Technical Service Bulletin

GROUP	NUMBER
CAMPAIGN	25-01-078G
DATE	MODEL(S)
OCTOBER 2025	GV70 (JK1, JK1A)

SUBJECT: FRONT BRAKE SQUEAL NOISE PAD REPLACEMENT
(LIMITED COVERAGE CAMPAIGN L01G)

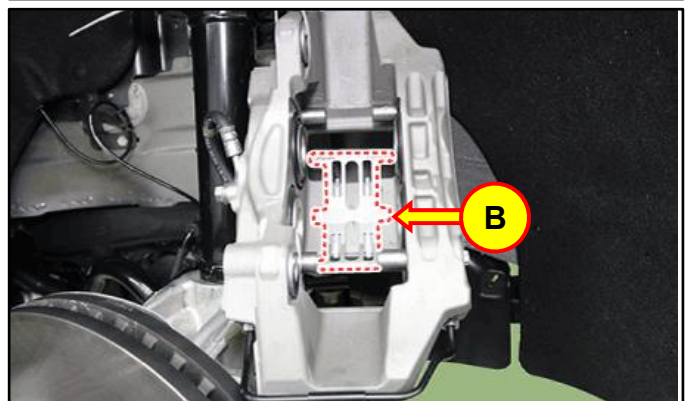
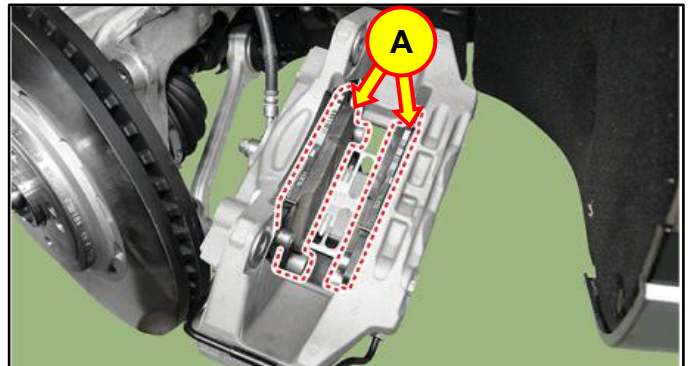
2. Remove both front brake pads (A) and radial spring (B) from both sides of the vehicle by referring to the shop manual:

3. Install the new radial spring and brake pads by referring to the shop manual:
 - **Brake System > Brake System > Brake Pad > Installation**
